NEW DENTIST OFFICE
CHERIE DDS, LLC

2142 MONROE STREET
HANDEVILLE, LA

SHEET TITLE:
BUILDING ELEVATIONS

DRAWING NUMBER:
A102

3 FRONT ELEVATION
SCALE: 1/4" = 1'-0"

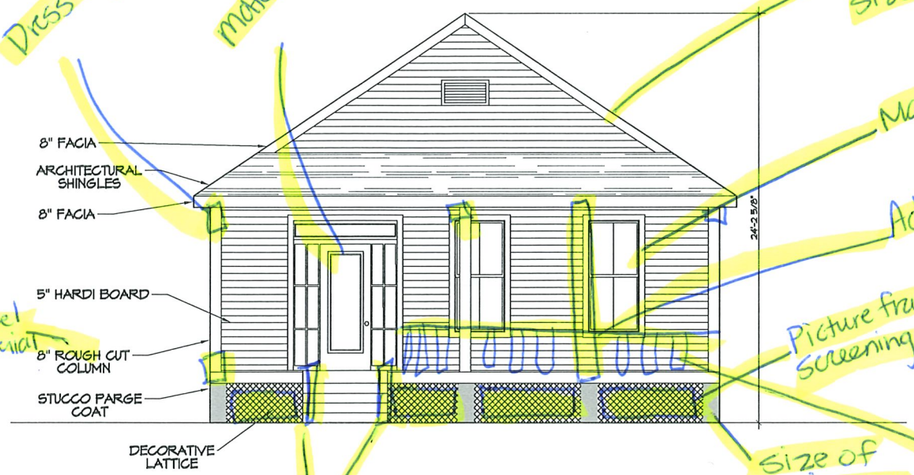
Dress up columns.

material?

Needs to show shingles
Roof Material?
Size? specs?

Material?

Add additional column.

Picture frame Screening.

Size of piers?

Railing needed.

Label material

Add railings
(show typical detail for measurements)

* No character defining features.
* Need some more elements added to design.

4 REAR ELEVATION
SCALE: 1/4" = 1'-0"

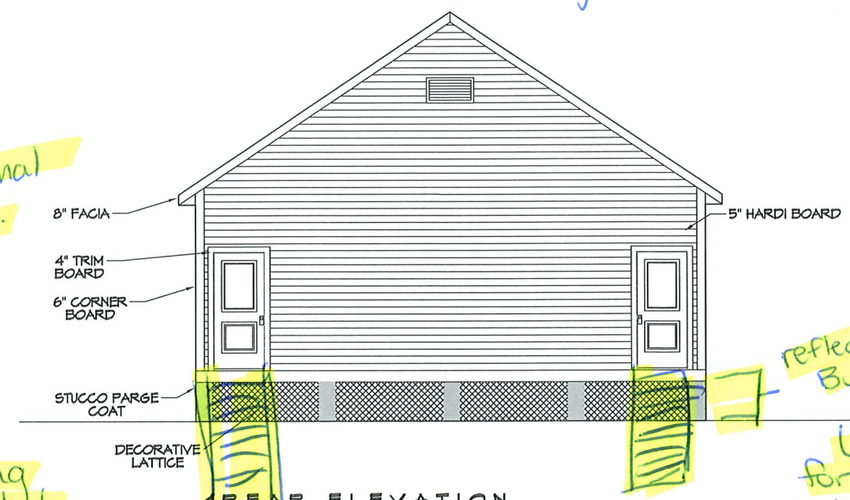
reflect Height of Building.

6ft min for BFE + 2'. Needs to be at 12' msl.

Add stairs

5 RIGHT SIDE ELEVATION
SCALE: 1/4" = 1'-0"

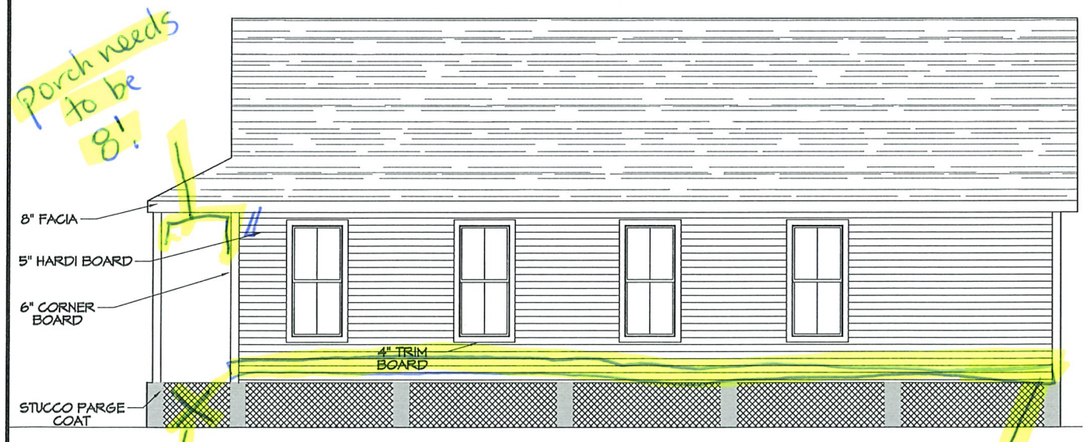
Porch needs to be 8'.

No screening under porch.

Add Fascia Board.
Building looks Floating

6 LEFT SIDE ELEVATION
SCALE: 1/4" = 1'-0"

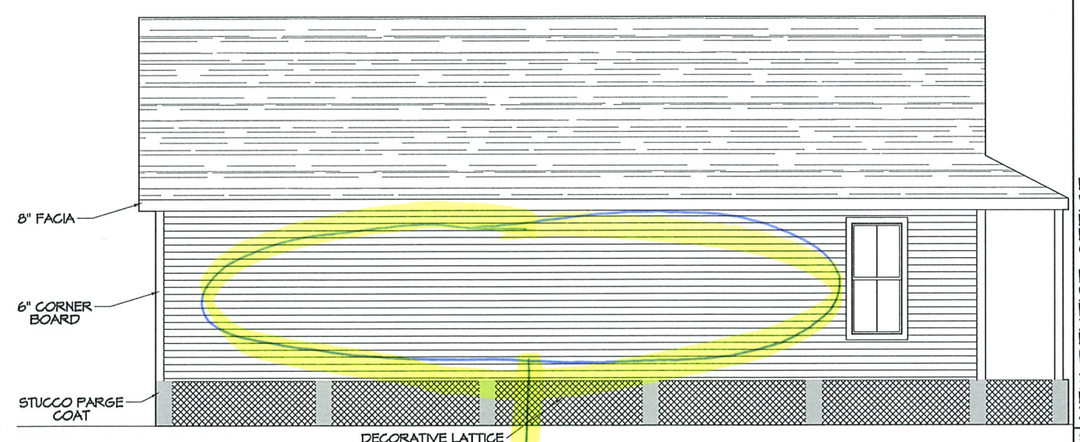
to open of a wall needs to be broken up.
